# NIOSH Response to SC&A Comments on ORAUT-RPRT-0072

Response Paper

National Institute for Occupational Safety and Health

January 4, 2019

Figure 1. SRS Tritium Annual Doses

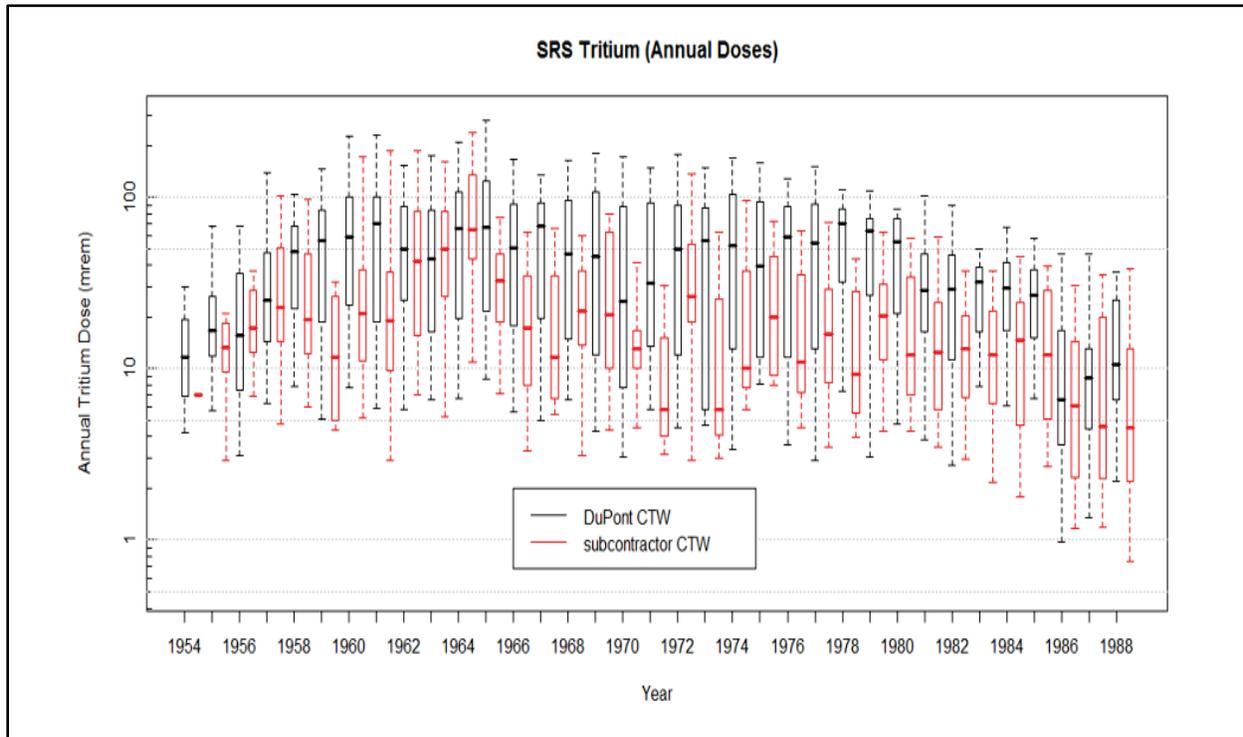
**SC&A Specific Question 3:** *In terms of potential operational sources of STCs, no discussion is provided for contamination during D&D activities, which were extensive during the 1990s (including the closure of the older tritium facilities). Given the engineering controls in place, the D&D phase would have been an operational phase with some vulnerability for SMT exposure.*

**NIOSH Response:** Co-worker intakes from tritium published in ORAUT-RPRT-0081, Section 4.2, cover all activities and are stratified between operations and trade workers, the latter being involved in D&D tasks (ORAUT 2017b). Construction trade workers (CTW) included both prime contractor and subcontractor workers.

Figure 1 shows a box plot of tritium dose statistics for prime versus subcontractor CTW. Median doses for subcontractor CTW are lower than the median dose for prime CTW in all years. The 95<sup>th</sup> percentile dose for prime CTW is higher than that of subcontractor CTW for all but three years.
